**MEMORANDUM**

DATE: December 16, 2004
 TO: Montgomery County Planning Board
 VIA: Rose Krasnow, Chief *RK*
 Michael Ma, Supervisor *Ma*
 Development Review Division
 FROM: Wynn E. Witthans, RLA, AICP
 Development Review Division
 (301) 495-4584

REVIEW TYPE: **Site Plan Review**
 CASE #: **8-97007A and 8-94031C**
 PROJECT NAME: **Kingsview Village, Section 8**
 APPLYING FOR: Approval of 195 multifamily units inclusive of 64 MPDUs and 53 TDRs
 REVIEW BASIS: Div. 59-D-3 of Montgomery County Zoning Ordinance

AMENDED SITE DEVELOPMENT PLAN
 KINGSEW VILLAGE - SECTION 8
 BARNSTOWN (6th) BLOCK DISTRICT
 MONTGOMERY COUNTY, MARYLAND

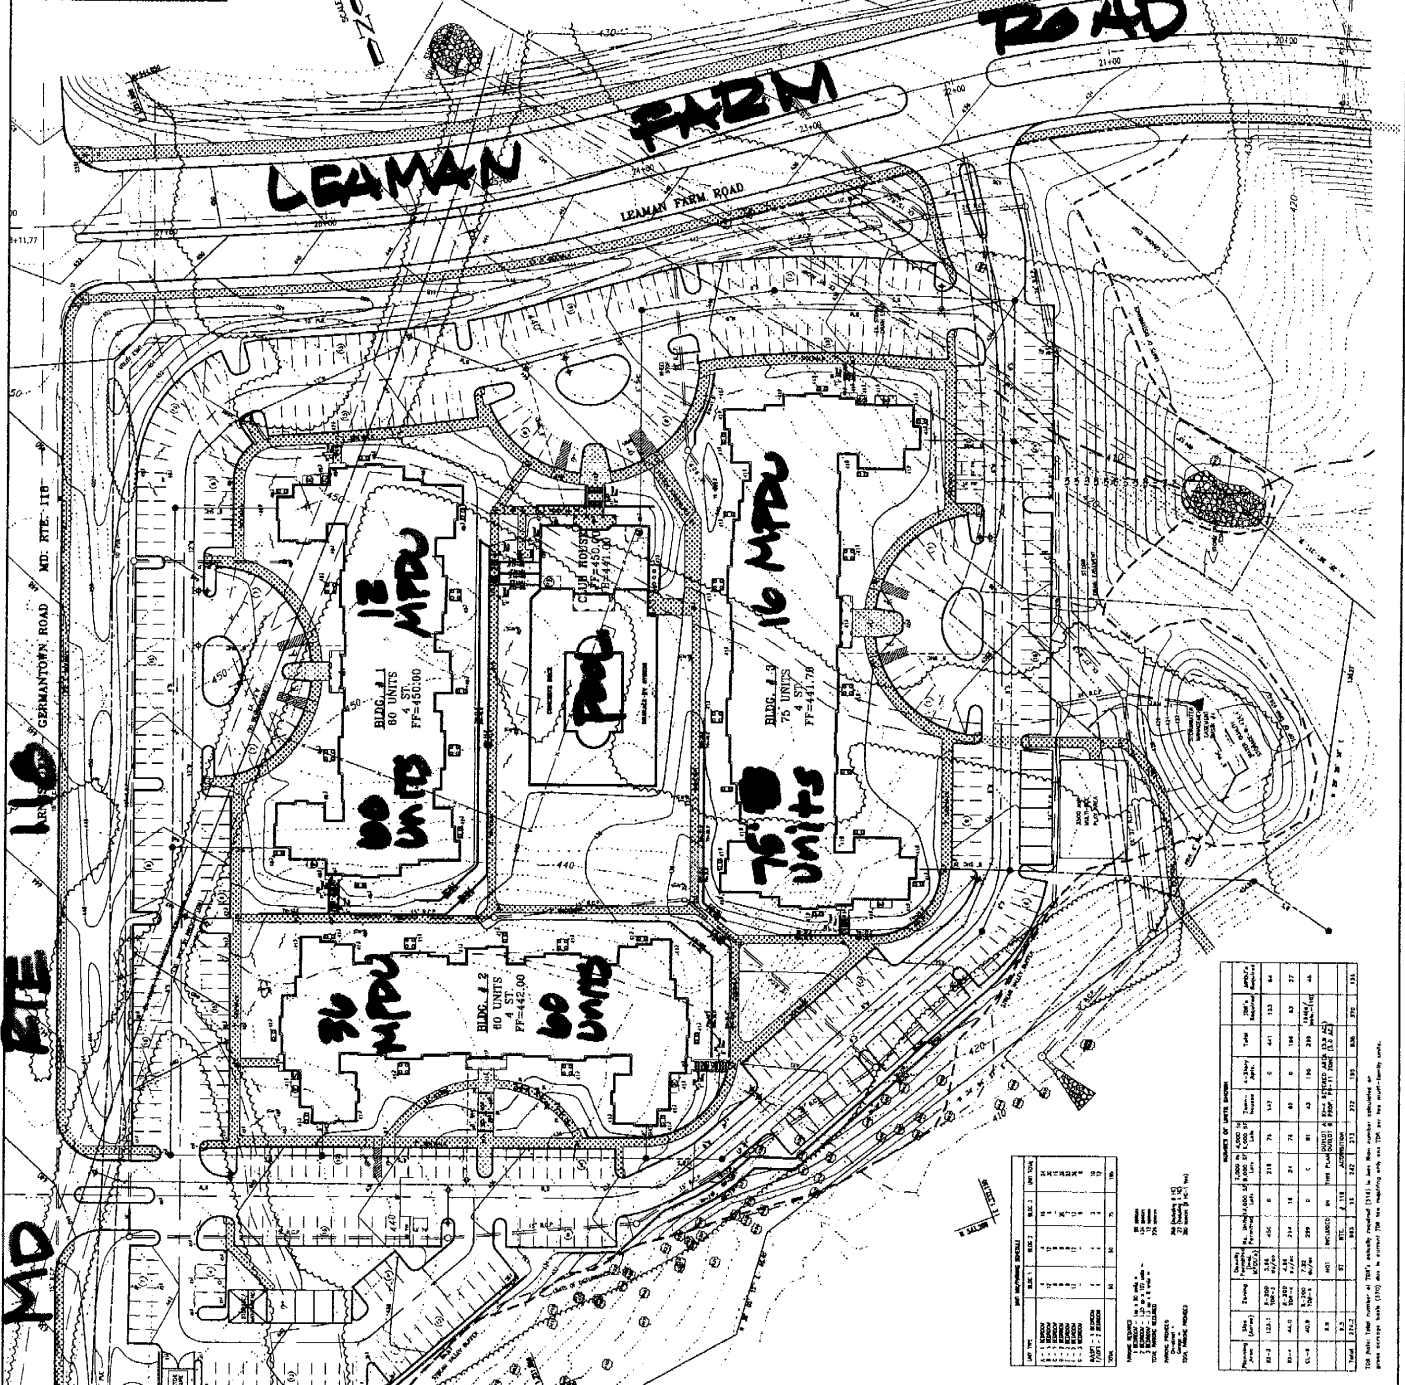
1. Site Design
 - a. Add two sitting areas adjacent to the front of the pool house entry.
 - b. Bike and motorcycle parking to be provided on site per Section 59-E.

2. Landscaping
 - a. Provide Street Trees on both edges and median of Leaman Farm Road, respecting eventual curb locations.
3. Lighting
 - a. Provide a lighting distribution and photometric plan with summary report and tabulations to conform to IESNA standards for residential development.
 - b. All light fixtures shall be cut-off fixtures.
 - c. Deflectors and house shields shall be installed on all fixtures causing potential glare or excess illumination, specifically on the perimeter fixtures abutting the adjacent residential properties.
 - d. Illumination levels shall not exceed 0.5 footcandles (fc) at any property line.
4. Pedestrian Circulation

Provide continuous sidewalk connection on MD 118 to connect to off site sidewalk to the northwest. Adjust street trees accordingly.
5. Maintenance Responsibility

Staff recommended additional sitting areas within the greenspace, sidewalk connections to the tot lot and off site, street trees adjacent the site on both sides of Leaman Farm Road and a revised sidewalk connection along MD Route 118. Landscape revisions have been made that removed planting from the public utility easements; increased planting in front of views from and to increase visibility to the tot lot. Along the frontage of MD Route 118, the applicant has also moved the sidewalk inward from the curb, a safer location away from the travel lanes.

Lighting is provided on the site as well. The light levels conform generally to IESNA standards. However, more detail is needed to analyze the light fixture to determine if it is designed to reduce glare and upward light pollution.

The proposed lights are Washington Globe styled light fixtures. The proposed lighting plan will include footcandle averages of 1.15 within the site. This falls within the IESNA parking light averages. The photometric point to point study needs to extend to the property lines show the light levels are .01 footcandles along all property lines. The light fixture selected need to show they are retrofitted to include reflectors that reduce the upward light throw and convert the fixture in to a full cut-off or semi- cut-off light throw pattern. The pole heights provided are 10 and 14 feet.

Recreation demand is satisfied as shown in the recreation calculations table above. The recreation will provide for a variety of outdoor exercise and play opportunities. Additional benches are required outside the swimming pool entrance.

Public sidewalks are located along Leaman Farm Road and MD Route 118 per earlier approvals. The sidewalks along MD Route 118 have been relocated from the curb to a right-of-way edge location where possible for increased pedestrian safety. This sidewalk connection needs to be extended to link to the sidewalk along MD Route 118 to the north west and along the Leaman Farm Road frontage of the property.

Street trees are required (in advance of lane construction) along the length of both edges and median of Leaman Farm Road in the future right-of-way per MCDPW&T cross sections.

The applicant has relocated the walk along MD Route 118 and it will connect with the existing sidewalk further to the west. It is adjacent to the curb in some areas to avoid environmental areas. The plans have increased landscaping per staff comments.

Additional screening has been added to the northern edge of the parking lot areas to screen the oblique view from MD Route 118. Additionally, the street trees along MD Route 118 have been re-positioned to be further away from the street edge to allow the tree to grow unobstructed and free from the traffic.
